Subject: RE: 67 Lawrence Road, London, N15 4EY - Submission of condition discharge and security gate applications

"LR2_VAB_AA_00_DR_A_3501_.pdf" shows two pedestals, one for each development; surely the two developments can share a single pedestal!

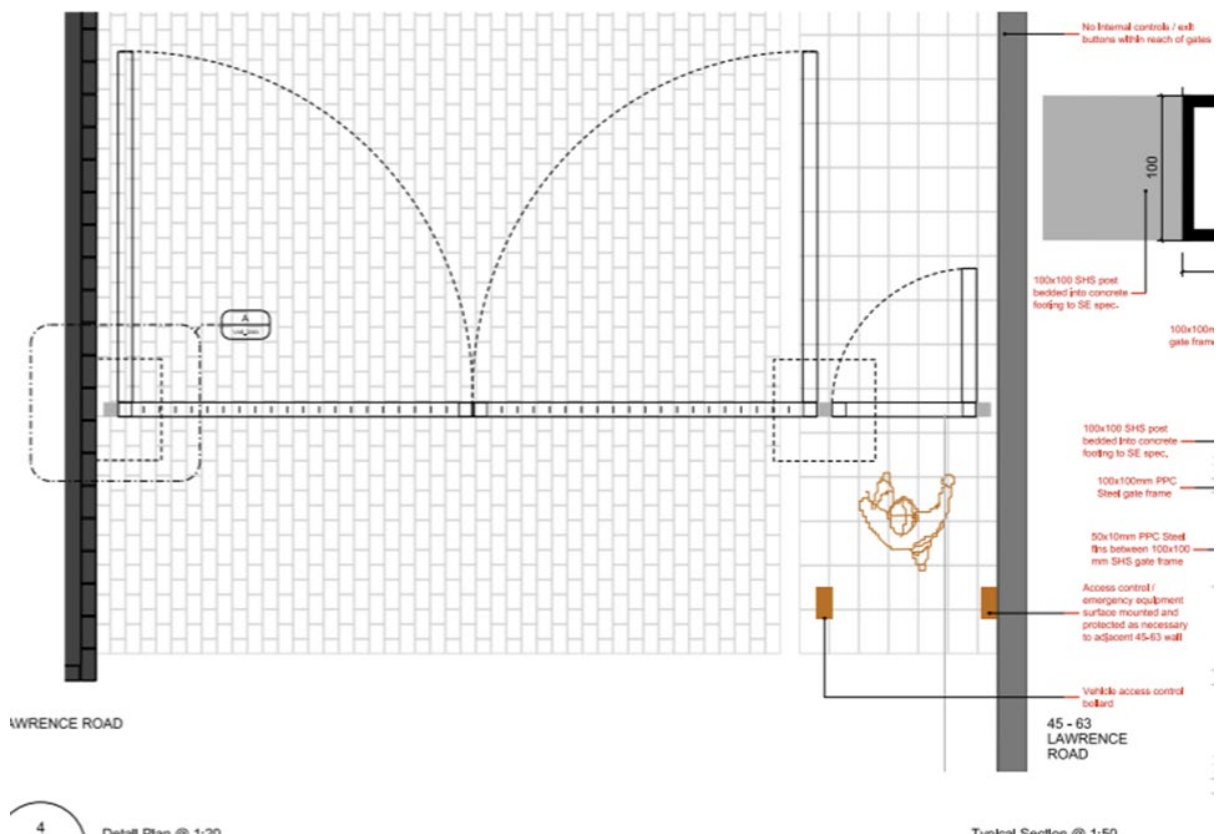
b) *I am very happy with the design of the pedestal. However, the plan*

Only 1 pedestal is provided for vehicle access and for use by both schemes (labelled "Vehicle access control bollard" below)

The second rectangle is wall mounted for the pedestrian gate and again is for use by both schemes (labelled "Access control emergency equipment surface mounted and protected as necessary to adjacent 45-63 wall" below)
